Our Ref: 20-12/001182
CRC Ref: mcuc 2021_4490/1
Date: 18 March 2022

RE: RESPONSE TO INFORMATION REQUEST IN RELATION TO AN APPLICATION FOR MATERIAL CHANGE OF USE FOR 'MULTIPLE DWELLINGS' AND 'SHORT-TERM ACCOMMODATION' OVER LAND AT 69 – 73 MURPHY STREET, PORT DOUGLAS

We hereby provide the following information in response to Council's Information Request dated 22 December 2021.

DA010.03

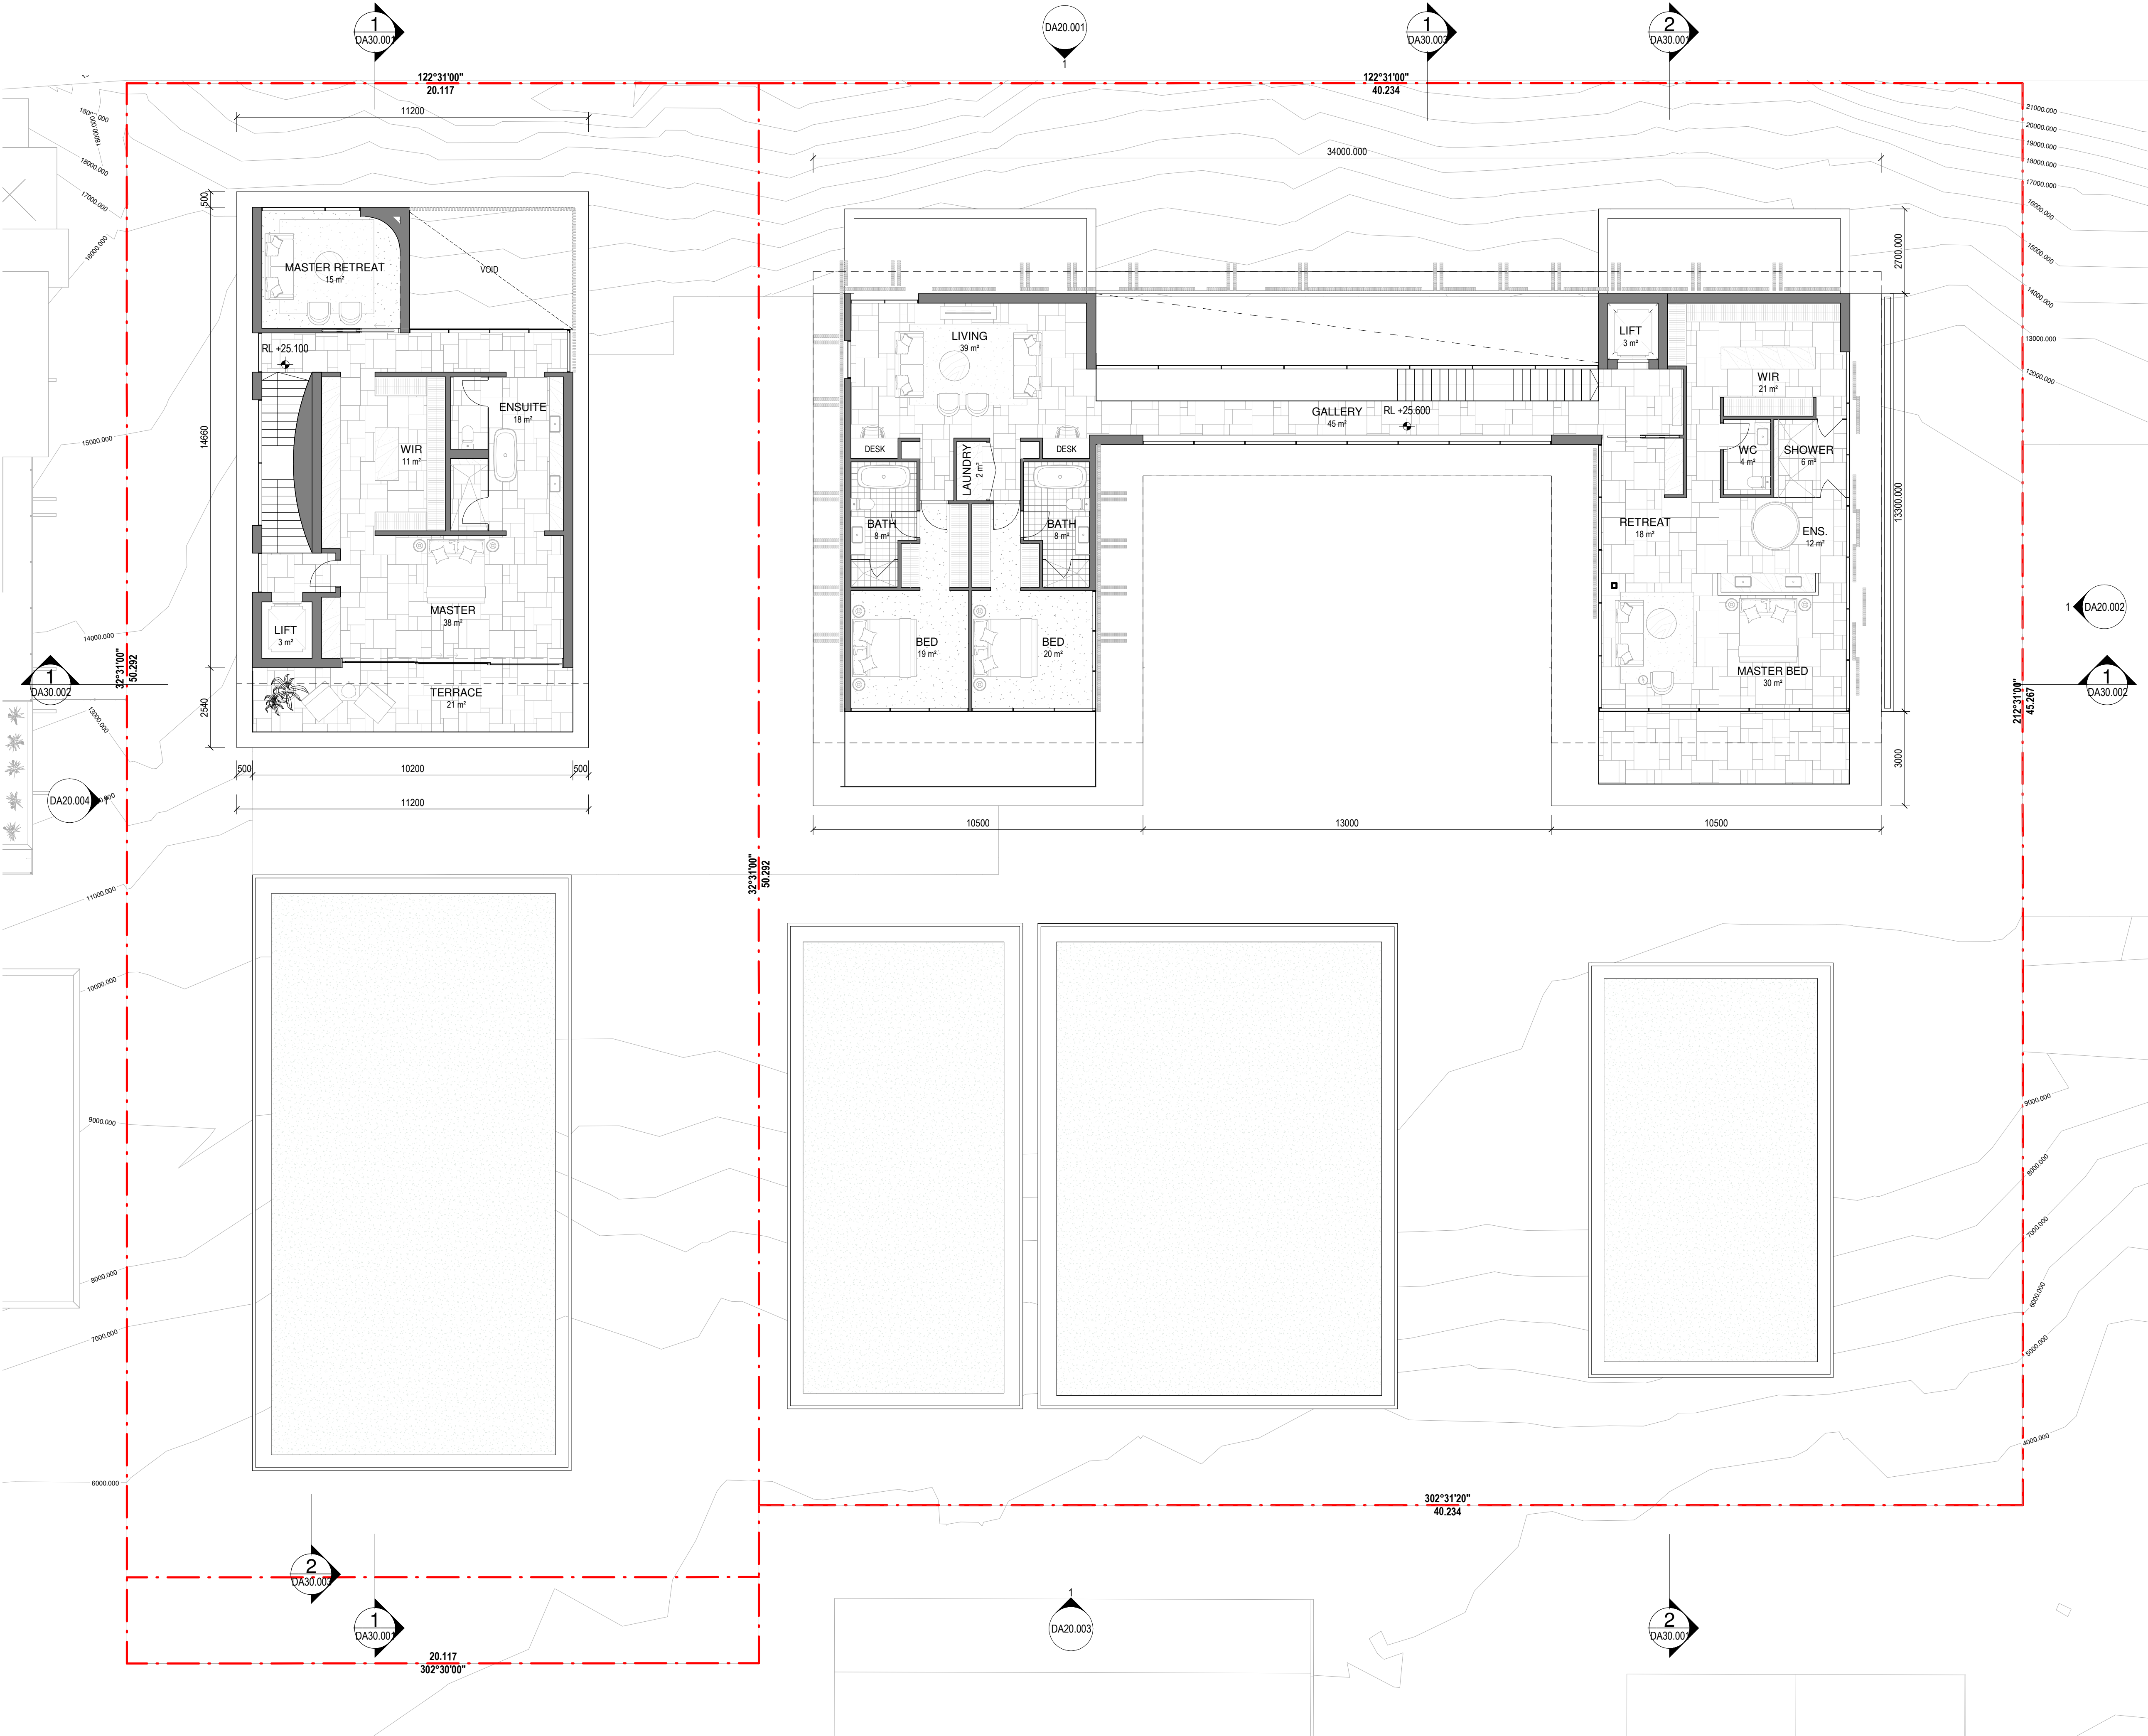
6. Drawing DA010.03 (Ground floor plan) and Sections 1 and 2 on Drawing DA30.001 indicate that the boundary wall adjacent Murphy Street is very close to the property boundary.

We refer to the Geotechnical Advice provided by GeoDesign which was included in the Development Application and refer you in particular to the “Stability” section. We note that the existing batter to Murphy Street exhibits stability issues and that the proposed development will rectify these issues in accordance with the geotechnical advice. Structural engineering details for the wall will be sought following approval of final plans and Council may condition the provision of this information prior to obtaining Building Works approval. The proposed construction of these elements are noted on the Architectural plans prepared by Warren & Mahony Architects included as **Annexure 1**

DA30.001

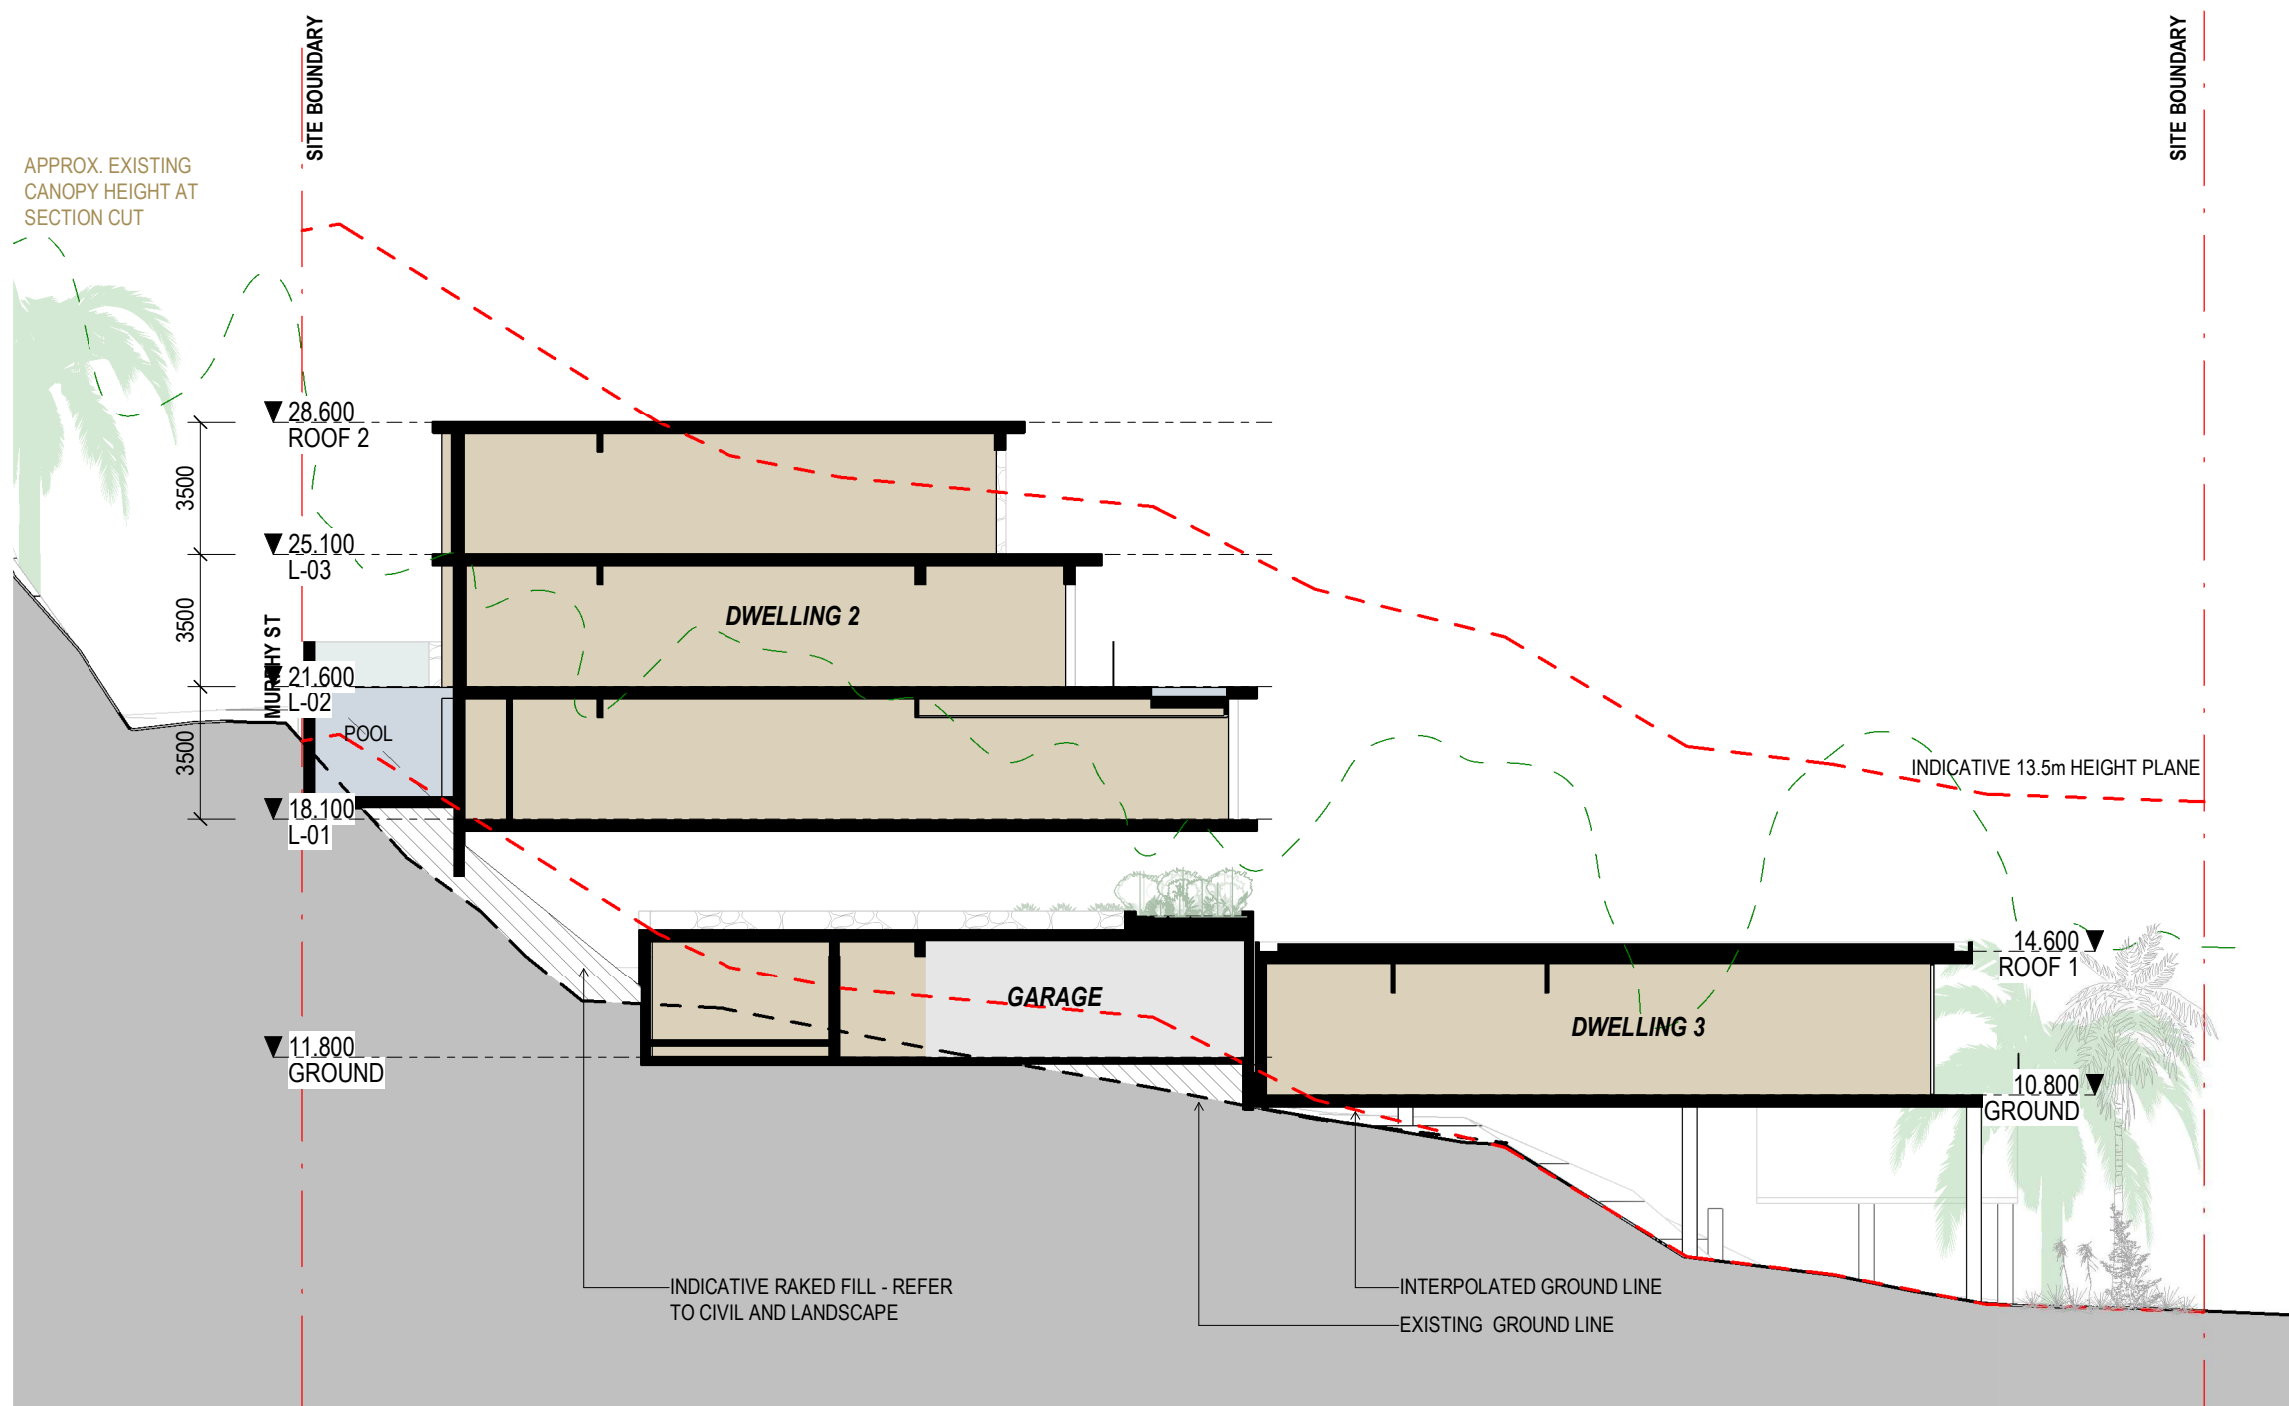
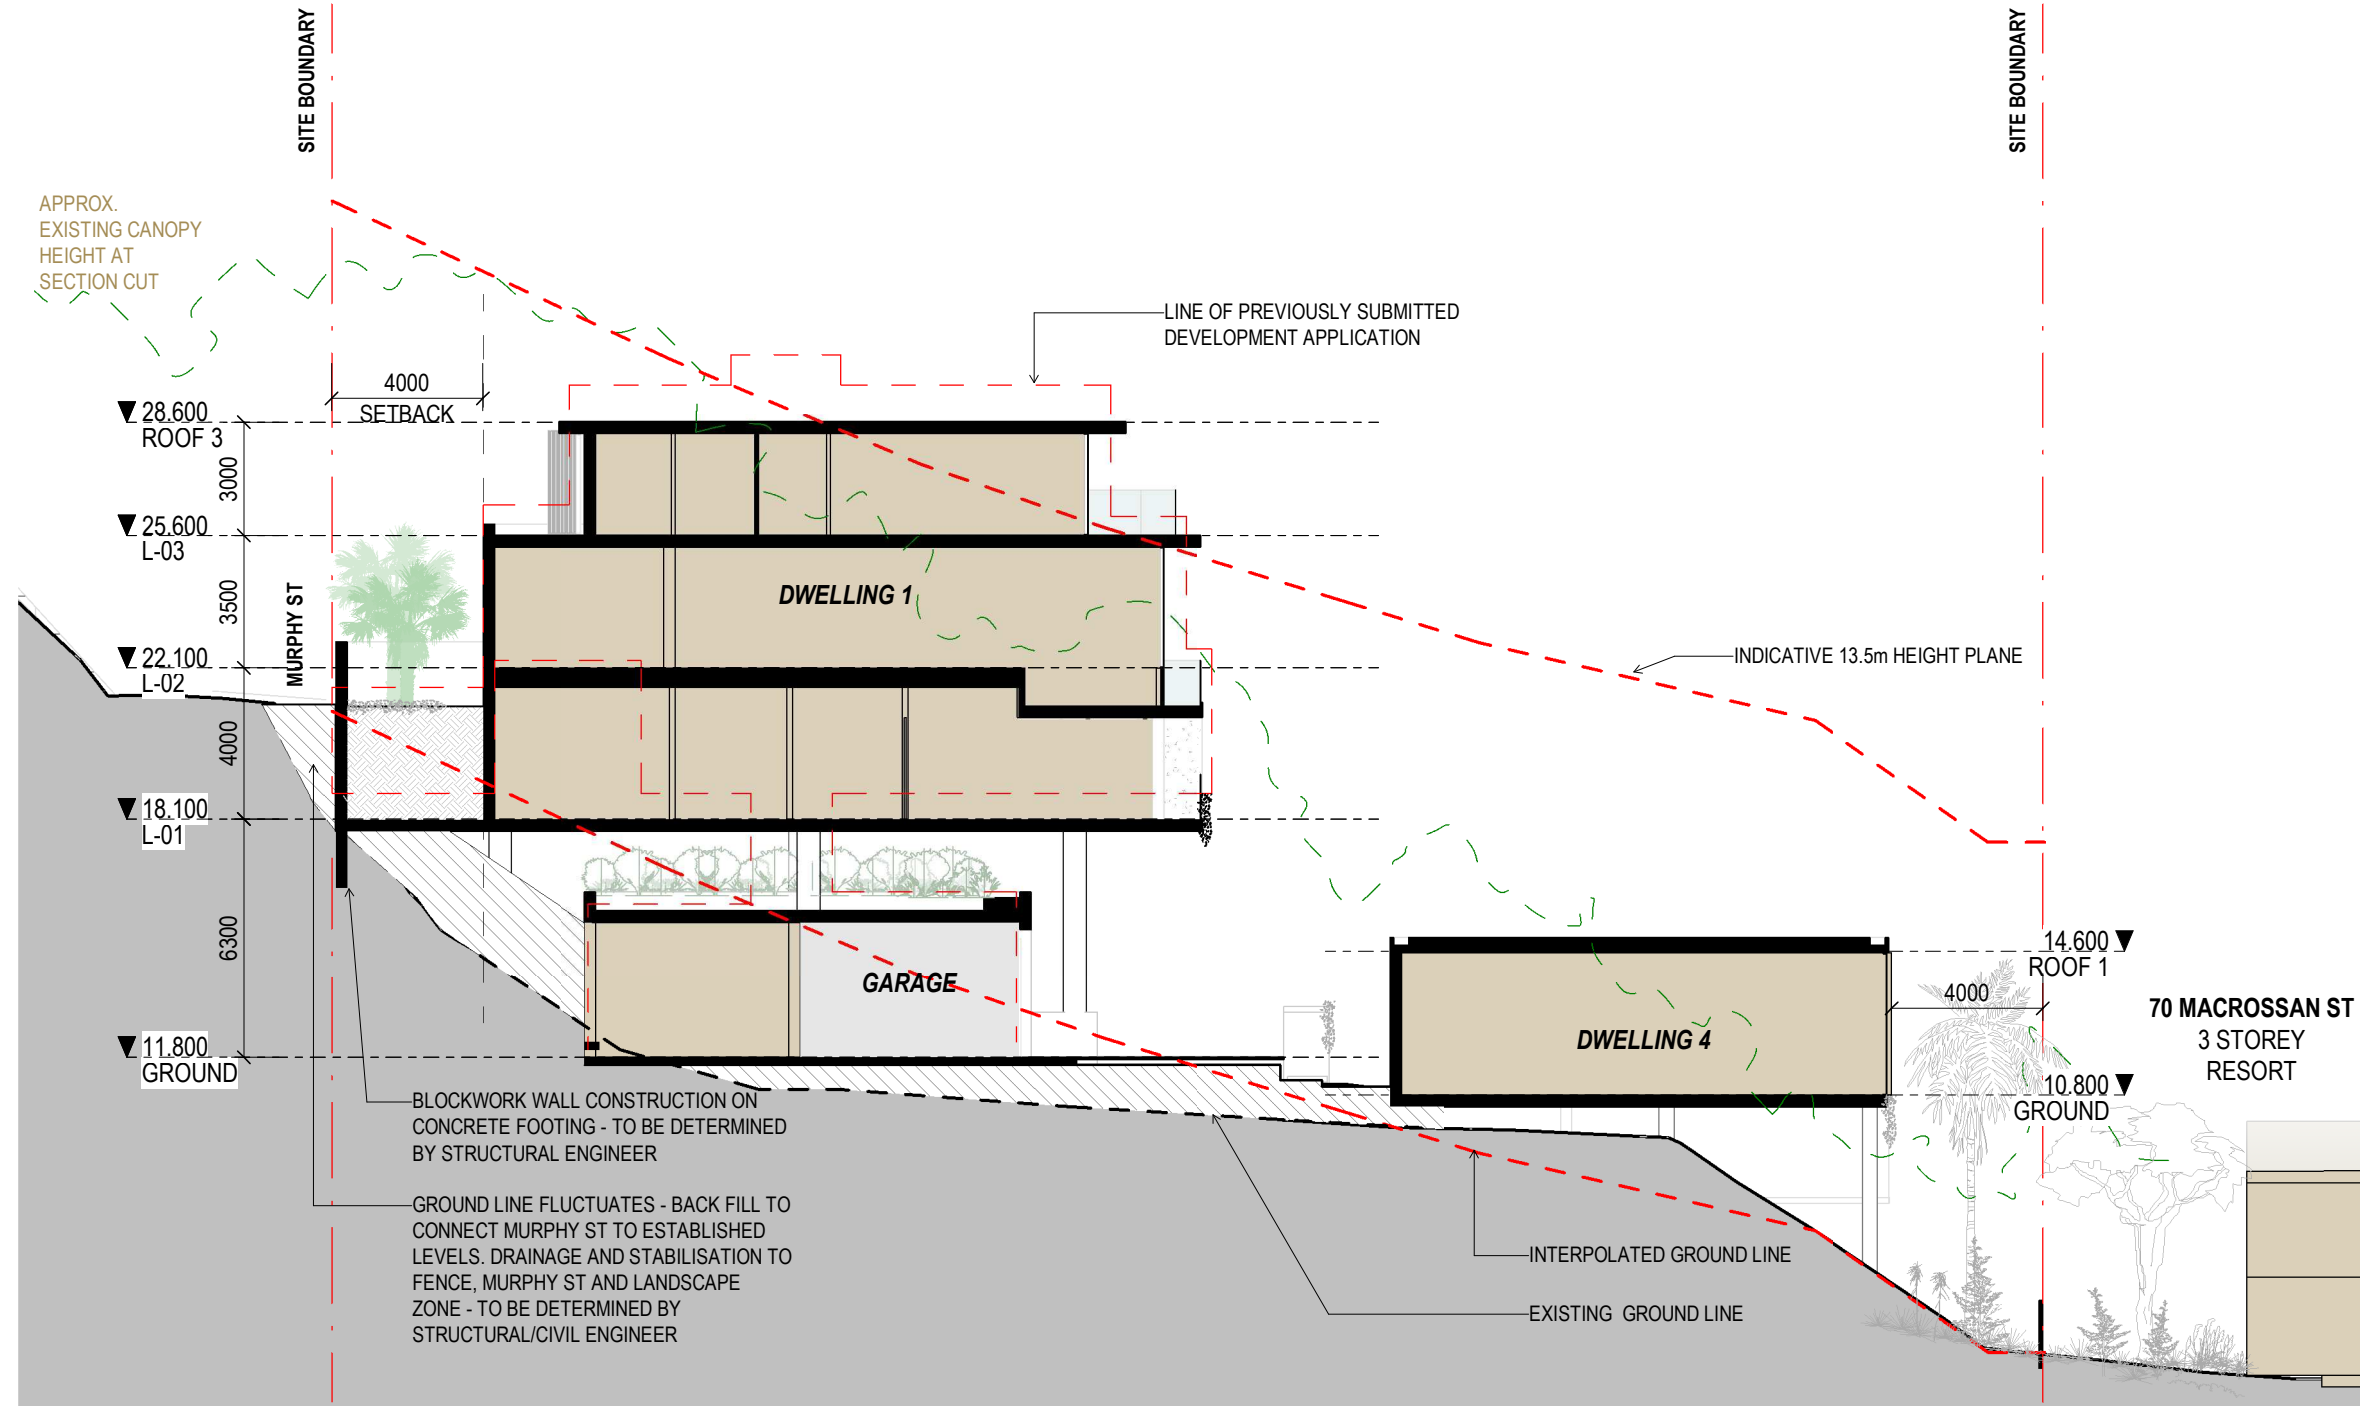
Section 1 on Drawing DA30.001 “Typical Sections” shows cut required in the existing batter potentially undermining the road reserve.

Section 2 on Drawing DA30.001 “Typical Sections” shows fill required within the site and extending into the Murphy Street road reserve.

The applicant is to confirm how the walls adjacent Murphy Street are proposed to be constructed and if any disturbance or reliance of Murphy Street is proposed to achieve the development outcome.

7. The applicant is requested to clarify the line-type/hatching used on Sections 1 and 2 on Drawing DA30.001 "Typical Sections" and on the East Elevation drawing DA20.002. Council Officers interpret that the diagonal hatching represents earthworks fill, the applicant is requested to clarify this interpretation.

- Legend has been added to sections – hatched pattern is indicative fill.
- Eastern boundary fence shown on Drawing DA20.002 is to follow the ground line and is nominally 1.8m high.
- Pool sections have been added (Drawing DA30.003) – these are a combination of suspended slabs and being cut into existing ground.
